New Cobar Complex Project, State Significant Development (SSD10419) Response to Submissions Report

Prepared for Peak Gold Mines
August 2021

Response to submissions report

Figure 4.1 Graph of transient vibration guide values for cosmetic damage

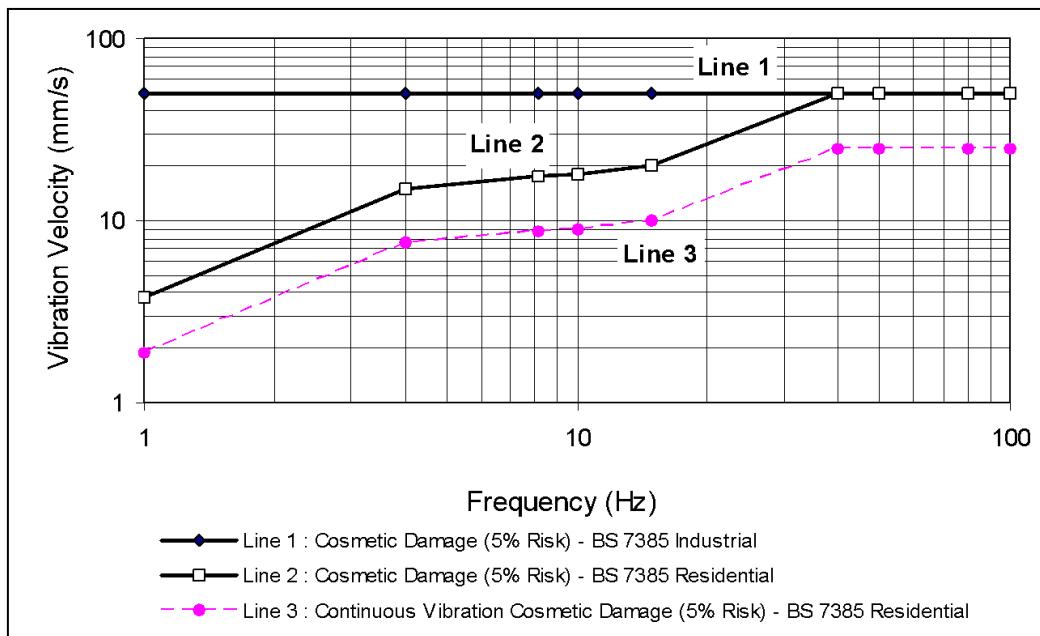
ID	Issue	Response
NV1	Vibration associated with existing operations at the New Cobar Complex has already caused damage to property. With the Great Cobar and Gladstone deposits being closer to the town and other residential properties, there are significant concerns that the damage will continue or increase.	Detailed answer in Section 4.4.1.
NV2	Concerned about the cumulative and long-term impacts of blasting on older buildings in Cobar town.	Detailed answer in Section 4.4.2.
NV3	Concerned that the traffic noise assessment for heavy vehicles only considers travelling along a road at maximum speed, and hasn't taken into account additional noises such as loading, changing gears etc.	Detailed answer in Section 4.4.3.
NV4	Current levels of operation and traffic noise such as rock breaking and reversing alarms at the New Cobar Complex already cause sleep disturbance and stress. Concerns that an increase in noise levels will be unbearable.	Detailed answer in Section 4.4.3.

The recommended PPV guide values for transient vibration to manage minimal risk of cosmetic damage to residential and industrial buildings are presented numerically in Table 4.5 and graphically in Figure 4.1.

In the lower frequency region where strains associated with a given vibration velocity magnitude are higher, the guide values for building types corresponding to Line 2 are reduced. Below a frequency of 4 Hz where a high displacement is associated with the relatively low PPV value, a maximum displacement of 0.6 mm (zero to peak) is recommended. This displacement is equivalent to a vibration velocity of 3.7 mm/s at 1 Hz (as shown in Figure 4.1).

Peak Gold Mines
New Cobar Complex Project
Response to submissions report
Figure 4.2

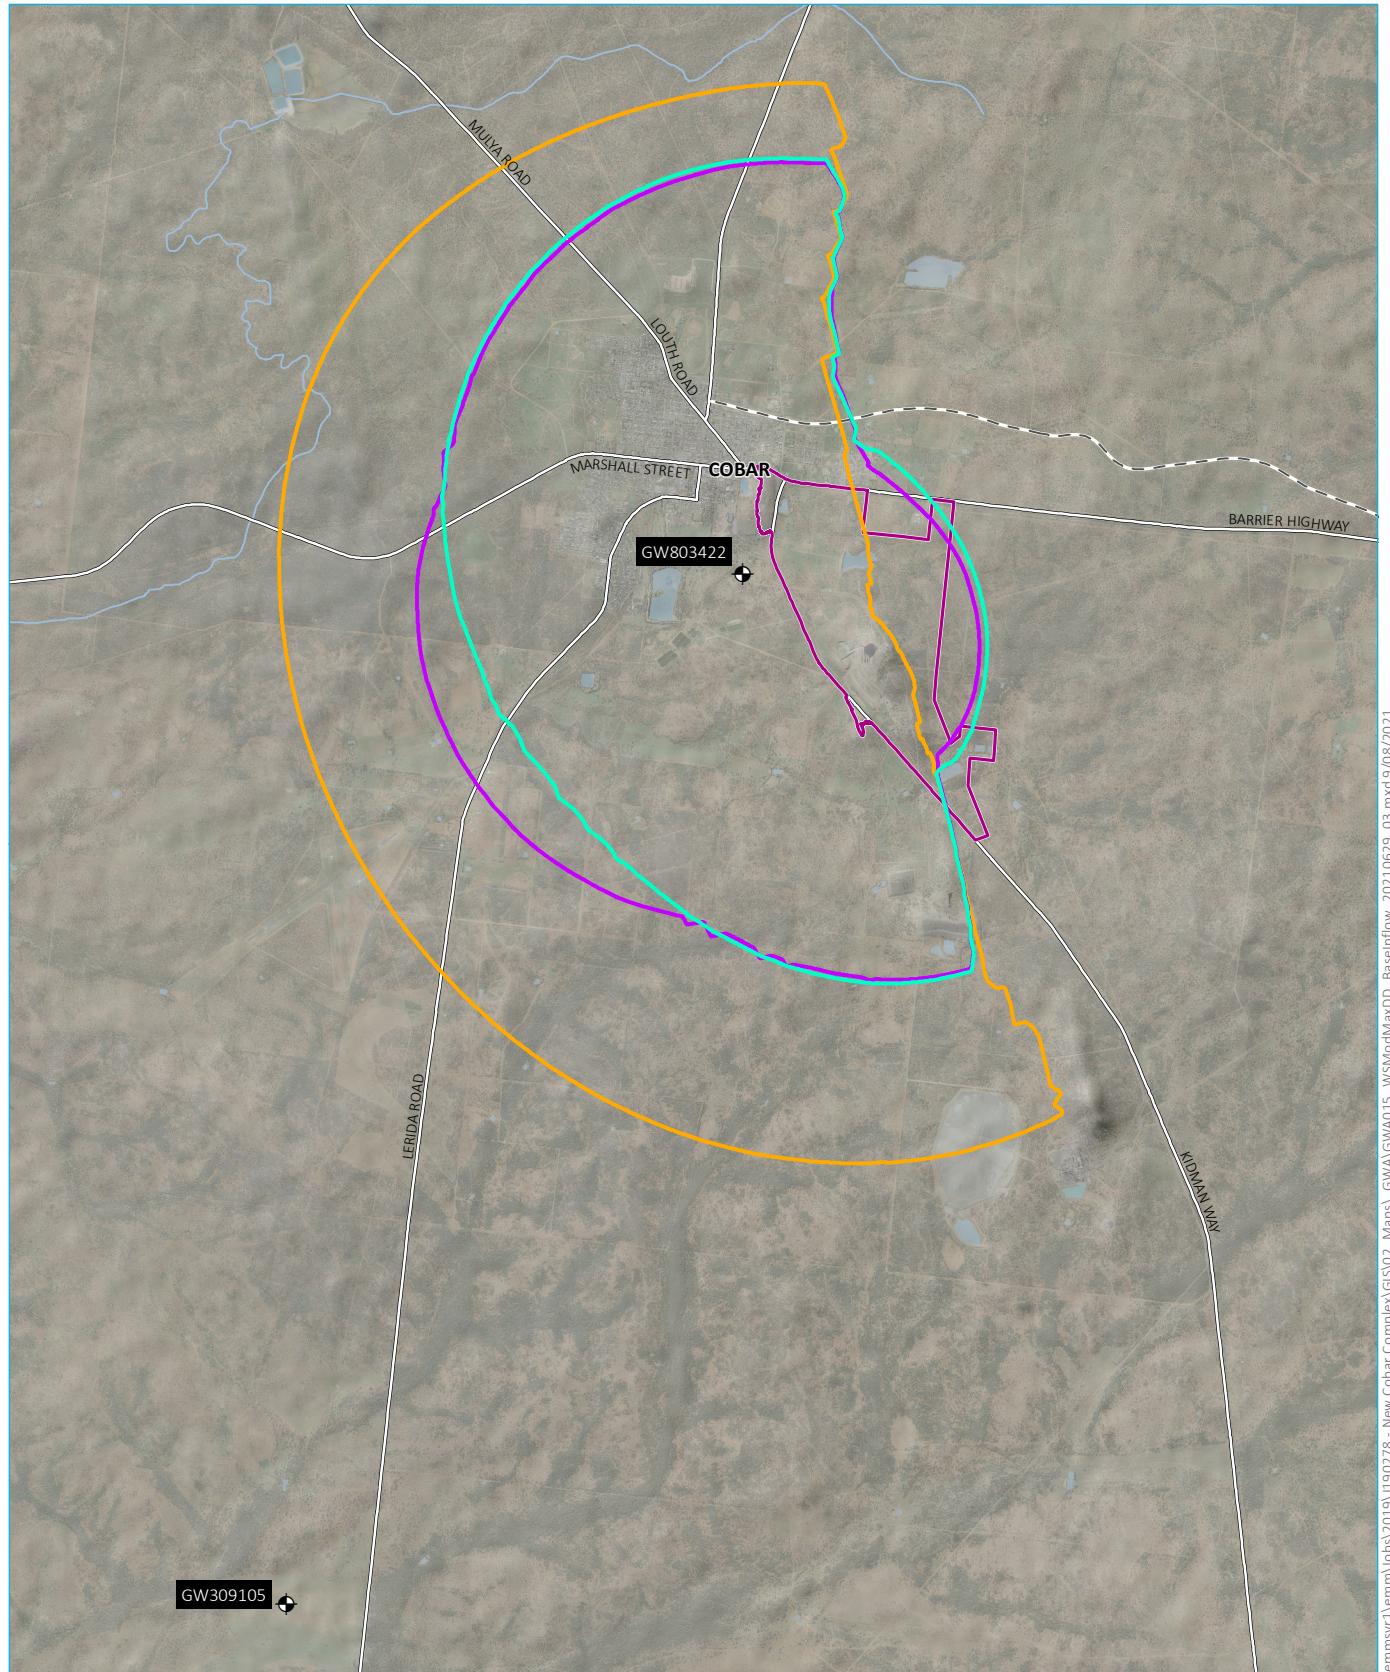
ID	Issue	Response
GW1	Loss of groundwater will cause the death of trees and vegetation. The lack of information on aquifers is inadequate for the groundwater modelling to accurately predict impacts.	Detailed answer in Section 4.5.1 below.
GW2	Concerned that make-good arrangements under the AIP will not be possible to implement in times of drought if town water is unavailable.	Detailed answer in Section 4.5.2 below.
GW3	Notes that the numerical model had been prepared in accordance with the Australian Groundwater Modelling Guidelines to a standard suitable for the scale of activity and the relatively low-risk of groundwater impacts in the area. However, the model was not independently peer reviewed as required by the Aquifer Interference Policy (AIP).	Detailed answer in Section 4.5.3 below.
GW4	Notes that a basic landholder rights (BLR) bore (85WA752553) had been overlooked in the assessment.	Detailed answer in Section 4.5.3 below.

The addendum to the GIA, included as Appendix D, was prepared in part to address the inclusion of groundwater bore 85WA752553 (also known as GW309105) within the groundwater mode domain. GW309105 is located approximately 12.5 km to the south west of Cobar, as shown in Figure 4.2.

Although the bore lies outside the simulated maximum extent of the 0.5 m drawdown contours over the entire predicted mining period, it was assumed that the bore is at low risk of impact from development of the New Cobar Complex. For completeness though, the bore was imported to the groundwater model and predictive model simulations were run to assess the potential impacts of dewatering associated with the New Cobar Complex Project.
